AMC Knit Composite Ltd.

24th February 2021 & 25th May 2021

Structural Safety Inspection Report

Item 1: Excessive storage loading on floors

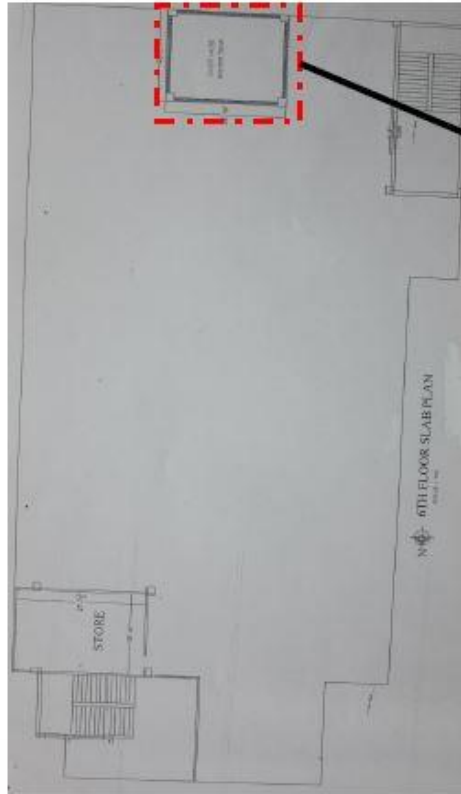
Loading on Roof

R.C.C Water Tank supported on 4 columns:
Length=7.9m
Width= 6.1m
Height= 1.64m(including top & bottom slab. Water level approx 1.2m)

Item 2: Discrepancies between Drawings and Actual Observations on 2nd, 3rd & 4th floors

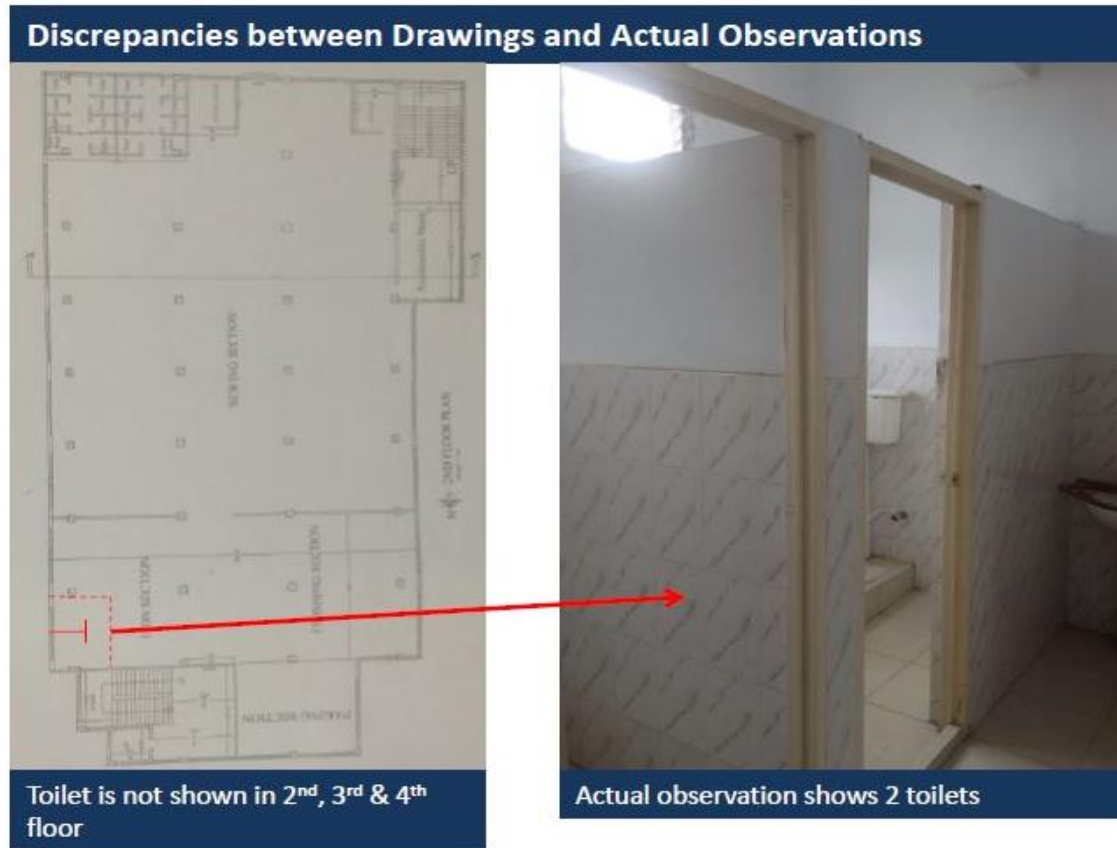
Factory engineer has carried out Detailed Engineering Assessment (DEA) based on the observation of ARUP report. Overstressed columns and footings observed in output of analysis file. Factory engineer suggested retrofitting to the over stressed members which is still under review.

Poor connection details

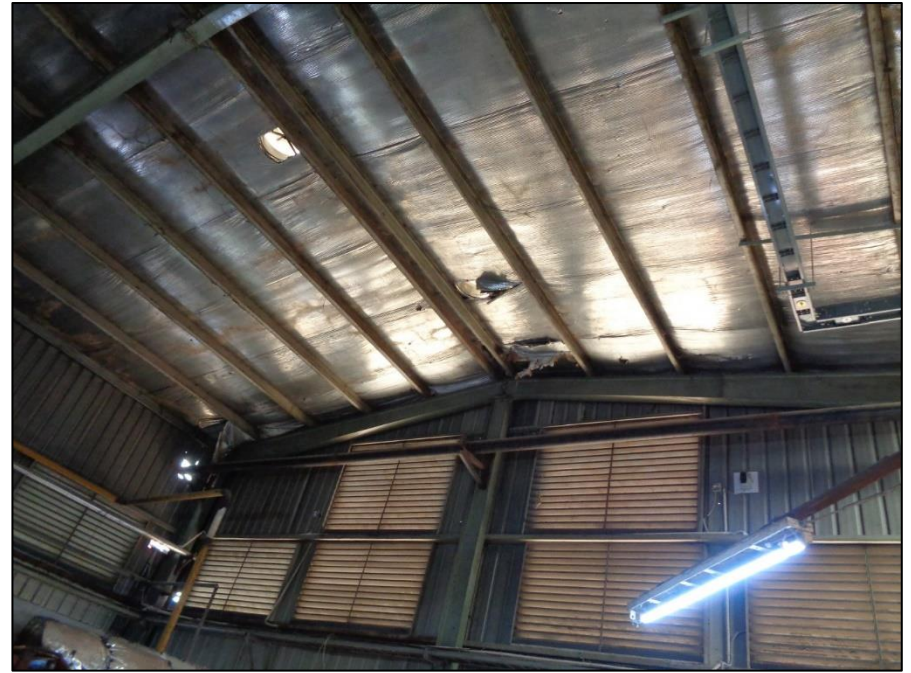
The steel roof shed made of angle truss which is supported over RC column. Poor connections were found. Building engineer is required to survey the whole structure and prepare accurate as-built drawings. Also check the adequacy of the members and lateral stability of the shed and prepare design document in compliance with section 1.9.1 (part-6, BNBC 2006).

Apparently non-engineered connection at roof shed

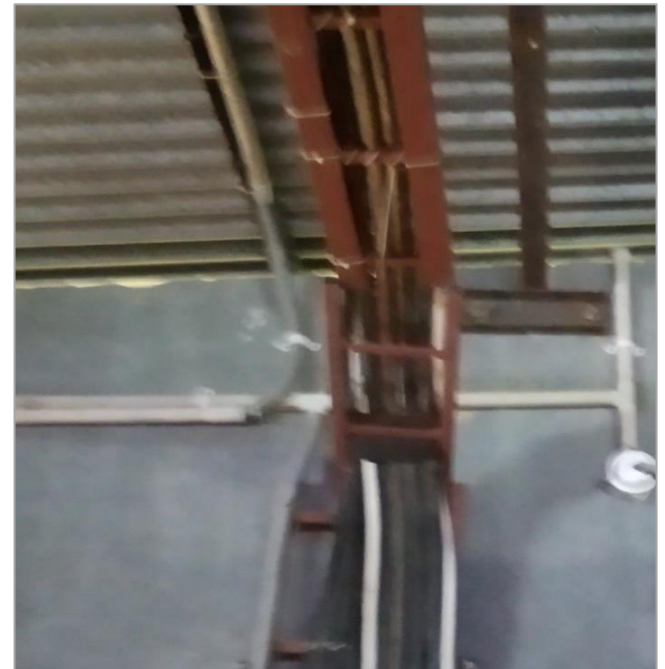
Poor connections were observed at roof. Moreover, as-built drawings and design report were not available. As per BNBC every building or structure designed shall have its design documents prepared in accordance with provision of Section 1.9.1. The design document shall include a design report, and a set of structural drawings, which shall be prepared in compliance with section 1.9.1.1 & section 1.9.1.2 as per BNBC. Factory Engineer is required to prepare as-built drawings and Engineering Assessment report in compliance with section 1.9.1 (part-6, BNBC). And check the adequacy of the connection.
